SPB Number: 2022.0303

FINISH UPDATE

STANDARD PLAN BULLETIN NOTICE
RaceTrac Engineering and Construction Division

- Sheet: A501
- Attachments: A501

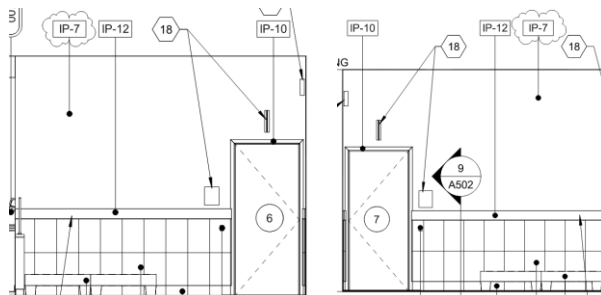
2. **WALL PAINT UPDATE:** Updated the wall paint outside of Men's and Women's restroom to be IP-7.
